Application Ref: 2014/6845/P

06 Landscape Masterplan: Amendment Response

Pears Building Pond Street London

Fig 11: Landscape Masterplan: Proposed amendment

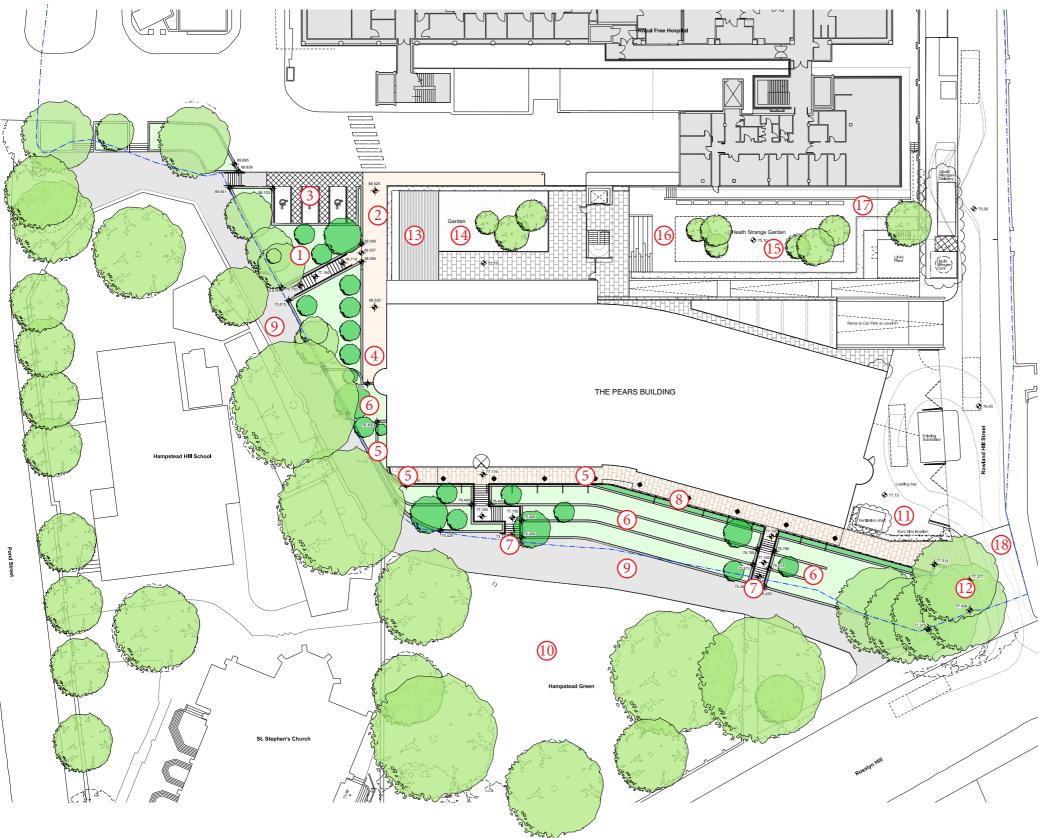
- Where possible the existing trees along School boundary and public footpath will be retained. Where existing trees require removal, new trees will be planted upon completion of the building works to mitigate the loss. New low level understorey planting established with shade loving species to create a 'soft' physical separation between the path and the new sloping landscape, in order to avoid the use of metal railings.

- North Courtyard removed and soft landscaping extended, allowing for wider area to be available for planting of new trees. Hard-paved path adjacent to the building's North elevation retained.

- 3. Both car park spaces retained (second car park space upgraded to serve as an accessible bay). A third accessible car park space added.
- 4. Lift lobby access to main entrance level retained. Lift now opens to the interior of the building, rather than to the external path. Canopy above removed - it is no longer needed due to the lift access changes.

- 5. Terrace Colonnade. The hard landscaped forecourt to the building, this will be surfaced in natural yorkstone flags, complimenting the character of the area and the warmer tones of the building. The colonnade has sufficient width to allow possible cafe external dining without impacting circulation at the front door. (Note: Terrace colonade to the North removed it is no longer needed due to the lift access changes. The removal of this section of the external terrace allows for better arrangement to the retaining walls at the North-West corner).

- 6. Planted Terraces (note: width of terraces reduced to allow for the public footpath to return as closely as possible to its existing footprint). A series of terraces of varying depth and width will be planted with native species and wildflowers utilizing the mix established on Hampstead Green. The terraces are not accessible except for two staircases. A 450mm high seating wall runs along the base of the lower terrace opposite the heart of the Green to provide informal public seating.

- 7. Feature steps through the terraces providing access to the Terrace Cllonade revised to accomodate the reduced width of the external terraces.
- Evergreen hedge planting at Terrace Colonnade level ensures planting is visible from inside the Lab work spaces.

- Existing public footpath (Note: the width of the existing path increased to allow for the path too return as closely as possible to its existing footprint).
 The resurfacing and remedial work at the base of the terraces is subject to further consultation.

- 10. Hampstead Green.
- 11. Screen Wall to service yard with climber planting at the base.
- 12. Existing London Plane trees retained, new low level understorey planting surround to open up views across from Rosslyn Hill. Existing retaining wall replaced with a low level kerb since the existing tree roots appear too close to the edge to allow for the construction of a new retaining wall. Appropriate wayfinding added to this location.

- Timber deck allows for UCL office breakout and activities. Positioned to maximise solar orientation.
- 14. Grass lawn and new tree planting.
- Grass lawn with replacement memorial tree planting forms the heart of a replacement for Heath Strange Garden.

- Steps and bleachers provide informal seating in the sunniest position overlooking the grass lawn.
- 17. Replacement memorial bench seating.
- 18. Junction of Rowland Hill Street and Rosslyn Hill resurfaced with granite setts to create a unified crossing point that emphasise pedestrian importance.
